**Drawing Amendments**

**Substance of Interview**

FIG. 2B

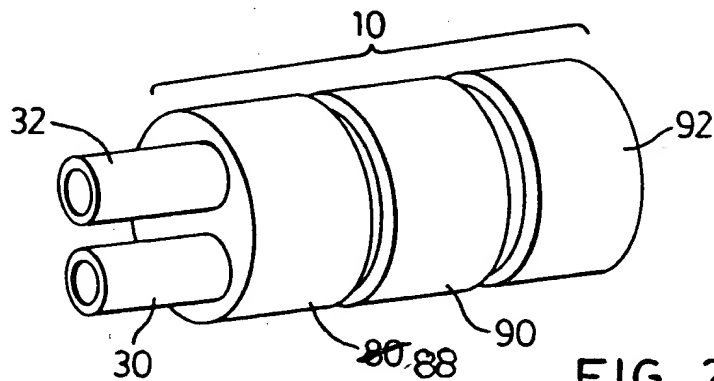
In the Examiner's June 21, 2005 report, the Examiner objected to the drawings because in Figure 2B (filed on 1/3/05), "80" should be changed to "88". Figure 2B has been amended accordingly.

In Figure 2B, Applicant has amended reference numeral "80" to read "88". The specific changes are marked in red on the enclosed marked-up copy of the amended drawings.
